Office Action Summary

10/735,446

DETAILED ACTION

FIGURE 1E: Examiner's Figure of the More reference

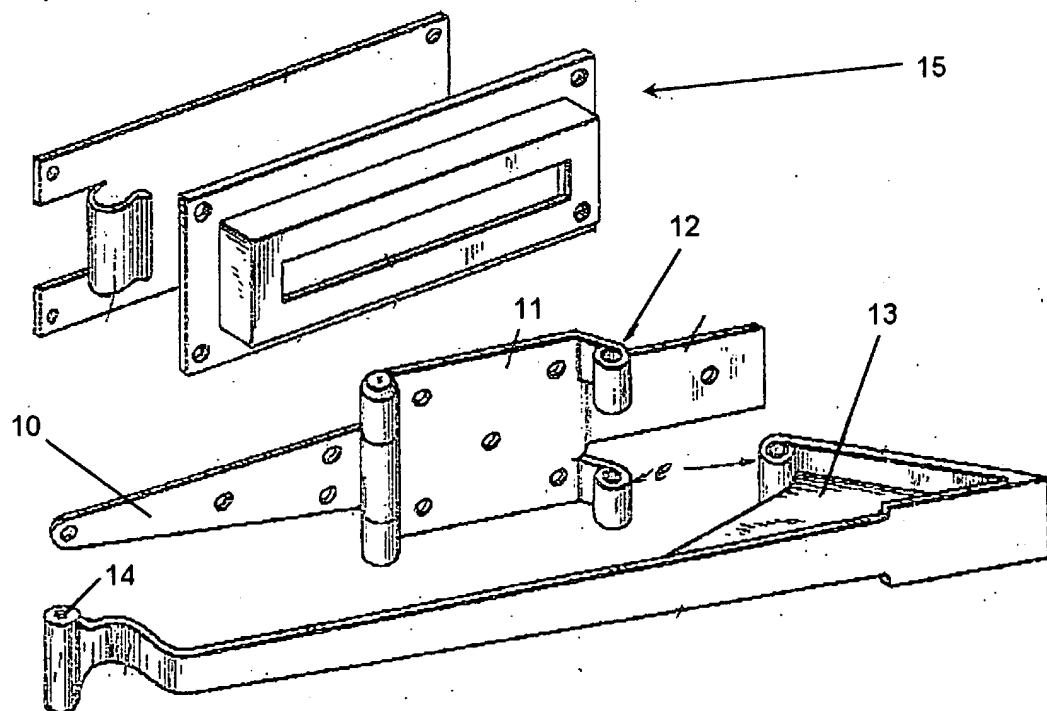
Claims 1, 10, and 30-32 are rejected under 35 U.S.C. 102(b) as being anticipated by US Patent No. 1,898,562 to More (Please see Examiner's Figure 1E below for reference).

In regard to claims 1 and 10 More discloses a door hinge fixture comprising: a first plate 10 having a surface for receiving a component (door); a second plate 11 having a surface for attachment to a frame or rack and cooperating with the first plate to

form a combination of mounting plates, and a flange 12 extending from a longitudinal edge of the surface of the second plate; wherein the first plate is pivotally connected to the second plate so that, in a first position, the first plate is adjacent to and in substantial alignment with the second plate and, in a second position, the first plate is rotated to an orientation which longitudinally projects from the second plate; and a locking mechanism 13 fixed to the flange of the second plate, wherein the locking mechanism includes a tip 14 which is movably coupled with the flange of the second plate for selectively engaging the component received by the first plate, wherein said tip is capable of being manually retracted.

In regard to claims 30-32, More further discloses a bracket 15 for association with the component received by the first plate and spaced from the hinge fixture, for selective engagement by the tip of the locking mechanism.

With respect to the rejections based on US Patent No. 1,898,562 to More (More), the Applicant recites, "there is no disclosure by More of a manually retractable locking mechanism which is movably coupled with the flange that receives it" (see Remarks, pg. 13, lines 23-25). On the contrary, More discloses a latch that is hingedly, and therefore movably coupled to the flange that it hinges with.

The lock mechanism (a), which includes tip (i) (see FIG. 4), meets the claim limitation "manually retractable." Because the limitation "manually retractable" is based on use by an individual, a reference need only be capable of being manually retracted, and need not be explicitly shown as being manually retracted. The applicant asserts, "manual engagement of the pin (i) is precluded" (Remarks, pg. 14, lines 15-16). However, tip (i) is formed as a unitary portion of member (a), which is inherently capable of being grasped and pushed in the direction of the closing door, thereby retracting the tip.

The Applicant further recites, "More also does not disclose 'a flange extending from a longitudinal edge of the surface of the second plate' . . . but rather positions the hinged connection e along a lateral edge of the hinge plate d" (see Remarks, pg. 14, lines 2-5). The terms "longitudinal" and "lateral" depend on the orientation of the device disclosed by More, as well as the present invention. It is well within the scope of the invention of More to position said device so as to support a door, window, or the like at any angle or orientation. Thus, depending on said orientation, what may be considered an edge extending in a "longitudinal" direction by one may be considered as extending in a "lateral" direction by another.

The Applicant further recites, "More also does not disclose "selective engagement of the component received by the first plate" (Remarks, pg. 14, lines 7-8). The limitation "to selectively engage the component received by the first plate" (claims 1 and 10) is interpreted to mean that tip is capable of being in an engaged position relative to the component, as well has a disengaged position. In More, the component is a door, including plate (m) attached thereto, and adapted to receive the tip (i) in its curved latch member (n) (analogous to the bracket 36 of the present invention shown in Figure 6). As shown in Figure 2 of More, the tip is in an engaged position with the door, because it holds the door in a locked, open orientation. When the tip is retracted (manually or otherwise) from the latch portion (n), the door returns to the orientation shown in Figure 1, disengaged from the tip (i). The fact that the device of More has a keeper to guide the motion of tip (i) does not detract from the fact that the tip engages the component in a first position (Figure 2), and disengages the component in a second position (Figure 1). It is further noted that the width of the keeper (j) relative to that of the tip (i) shown in Figure 2 of More indicates that the tip and arm assembly (a) are capable of being completely out of contact with the keeper, as well as the door and plate (m).
